Environmental Assessment

NFE Altamira FLNG Facility

DOE/EA-2226

Appendix B: Response to Comments on Draft Environmental Assessment

Figure 1. Location of NFE Altamira FLNG Facility and plat showing platform arrangement (Source: Google Maps and Application)

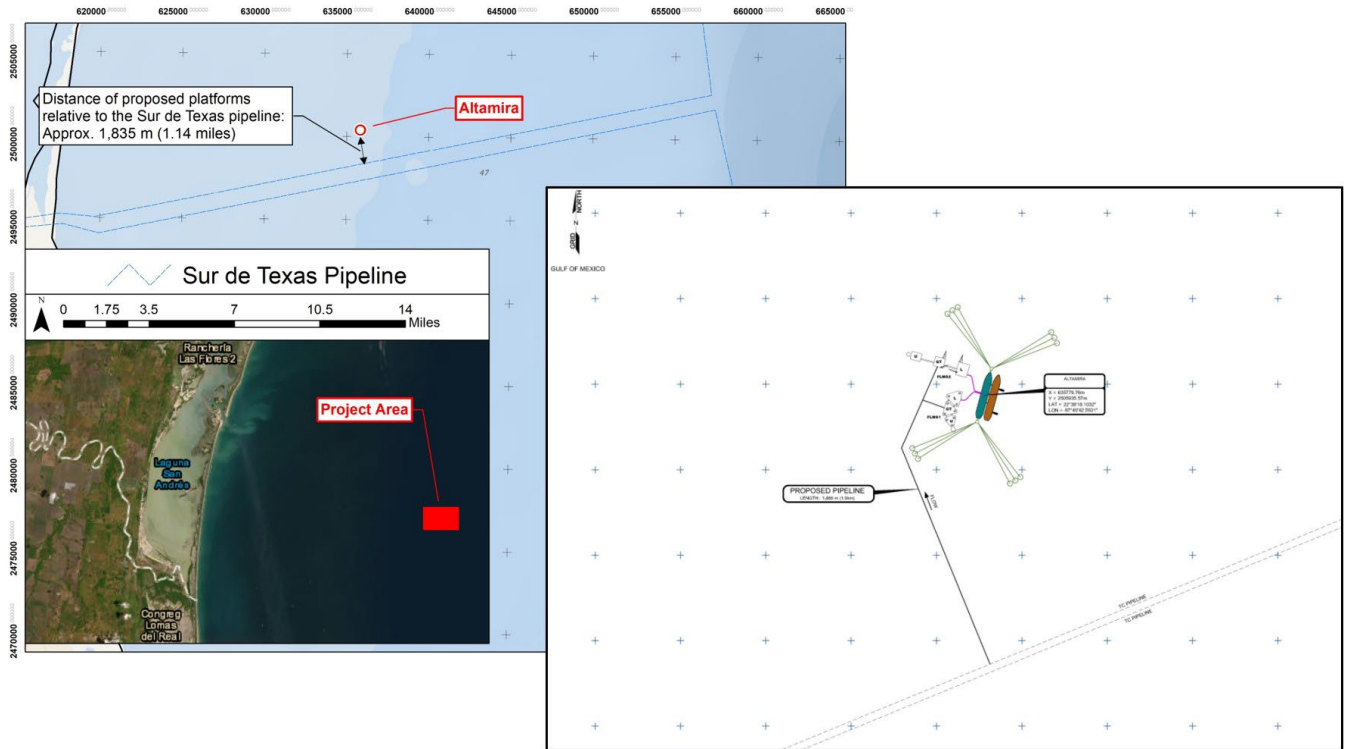
Commenter	Comment Document Reference	
NFE Altamira	Facility Configuration (NFE Altamira comments, pp. 2-3)	
<p>DOE Response</p> <p>NFE Altamira made a comment relating to the Draft EA’s discussion of “jack-up” rigs. NFE Altamira stated that it is “committed to the safe operation of the Facility.” It also provides information about its engagement of Lloyd’s Register to conduct engineering and safety evaluations and that Lloyd’s Register “determined the Facility to be safe and ready for commissioning/operation.” (p. 3) NFE Altamira also provides information about this review process. DOE acknowledges NFE Altamira’s statement that it is committed to safe operation. DOE has added text to the Final EA to reflect this additional safety information provided by NFE Altamira.</p>		
NFE Altamira	Comments Filed by TCEQ (NFE Altamira comments, p. 4)	
<p>DOE Response</p> <p>NFE Altamira points out (p. 4) that comments filed by Texas CEQ refer to groundwater contamination and management of industrial and hazardous waste. NFE Altamira states that “...no construction or modification of facilities in Cameron County is proposed in connection with NFE Altamira’s request for export authorization.” DOE notes NFE Altamira’s comment and has responded separately in this document to Texas CEQ’s comments.</p>
